Docket Item #2
Encroachment #2009-0001
3500 Goddard Way – Quaker Ridge

Application	General Data	
Project Name: Quaker Ridge	PC Hearing:	May 7, 2009
	CC Hearing (SUP and ENC):	May 16, 2009
Location: 3500 Goddard Way	Zone:	RB/ Townhouse Zone
Applicant/Address: Duke Crossing Inc	Small Area Plan:	Seminary Hill

Request for approval of an encroachment from a retaining wall onto public right-of-way along Duke Street.

Figure 1: Location of Encroachment

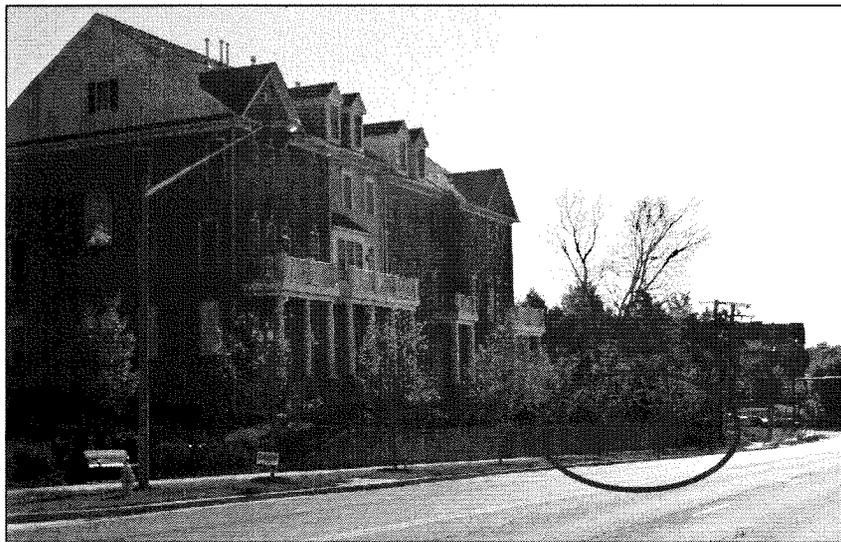
Staff supports the proposed encroachment. At approximately 4 inches, the encroachment into the public right-of-way does not create a significant impact and will not be noticeable to pedestrians using the sidewalk. The sidewalk and planting strip between the wall and Duke Street provide an adequate buffer for pedestrians along this portion of Duke Street. Approval of the encroachment would accommodate a small error made during construction and prevents the applicant from

having to remove and replace the wall in this location, which is a considerable expense, given that construction of the units on the site is complete.

Staff recommends **approval** subject to compliance with all applicable codes and ordinances and the following conditions:
